Our ref: 062001-05

**Re: Tallawarra B Power Station – Plume Symbol Amendment**

Figure 1 Katestone Figure 9

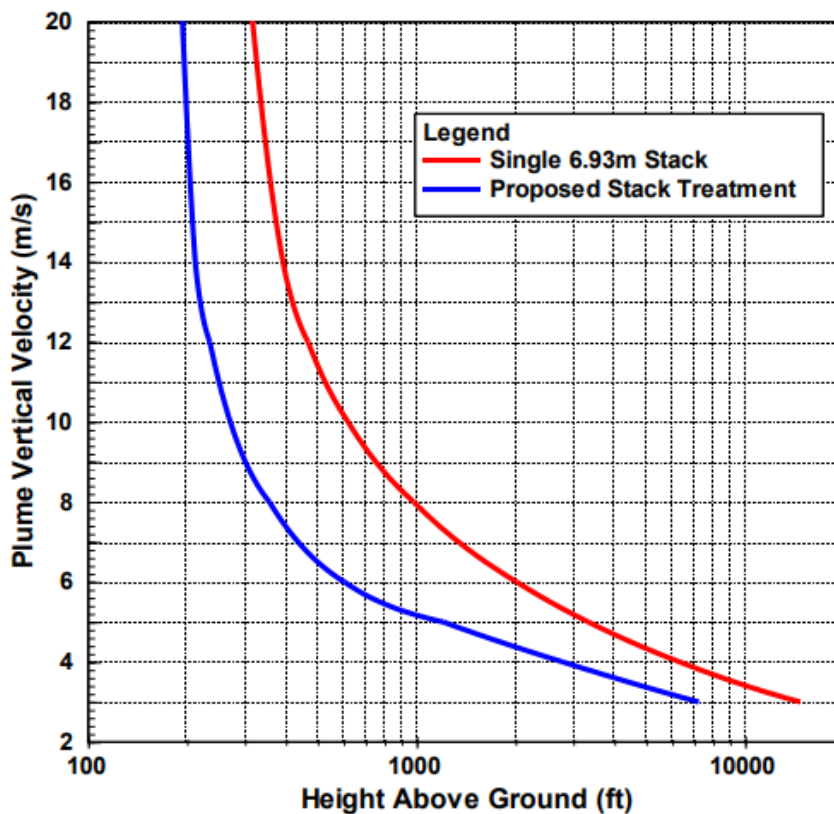
The AIA was based on an early simplistic model of the plume dispersal device (PDD), which found that the vertical velocity of the plume gradually reduced with height from a maximum at the point of release. The critical plume height of 6.1 m/s was found to occur at 580 ft AMSL. The image at Figure 1, extracted from the report

Figure 2 Stacey Agnew Figure 12 – initial meteorological case

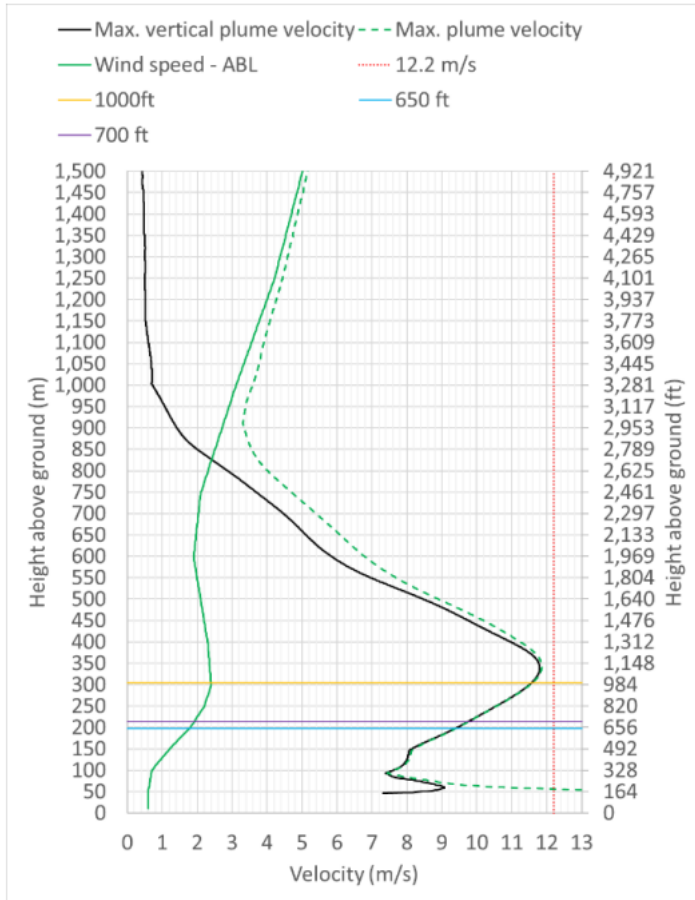
It can be noted from Figure 2 that, unlike the simple reducing velocity trend in Katestone Figure 9, the maximum transient peak vertical velocity (black line) initially drops but at about 250 ft the velocity starts to increase with height, reaching its maximum of just below 11.8 m/s at around 1148 ft AGL.

The maximum transient peak vertical velocity then reduces gradually with elevation. So, at no elevation does the maximum transient peak vertical velocity exceed 11.8 m/s according to the analysis.

Stacey Agnew (2023) found that the time-averaged peak vertical velocity for the initial case is 0.8 m/s less than the maximum. Therefore, the time-averaged peak vertical velocity does not exceed 11 m/s at any elevation AGL. Dividing this value by 2 gives an average vertical velocity of 5.5 m/s. This is less than CASA's critical velocity of 6.1m/s.

Figure 3 Extract of Sydney VNC showing plume symbol

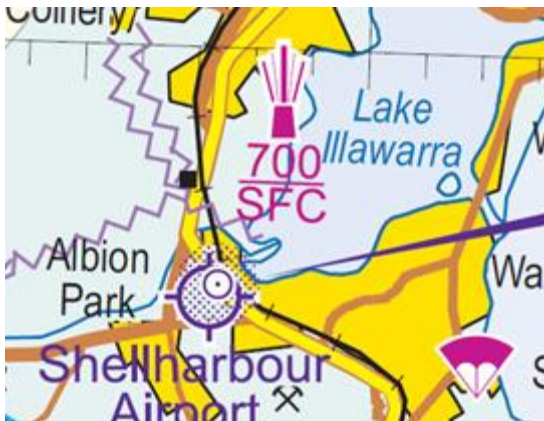
CASA has since asked, in meetings with the Department of Planning and Environment and EnergyAustralia, if the plume symbol needs updating given that the current design would result in the plume velocity increasing with height. Specifically, it was interested to know whether the plume symbol should be amended to show 700 ft AMSL and another height to provide pilots with as much information as possible to avoid the fastest part of the plume.

The fastest part of the plume, of the three modelled meteorological conditions occurs in the combined meteorological scenario between approximately 900 ft and 1700 ft AMSL. Although, this has an estimated probability of substantially less than  $1 \times 10^{-5}$ .

Publishing these heights in conjunction with the plume symbol would likely be inconsistent with historical methodologies, and while providing additional information to pilots, may introduce confusion because of the non-standard representation.

It is recommended that the plume symbol and associated Additional Information is Shellharbour Airport's En Route Supplement (ERSA) facilities (FAC) page be amended to reflect the region of highest velocity plume, which remains below 6.1 m/s, is likely occur between 900 ft AMSL and 1700 ft AMSL.
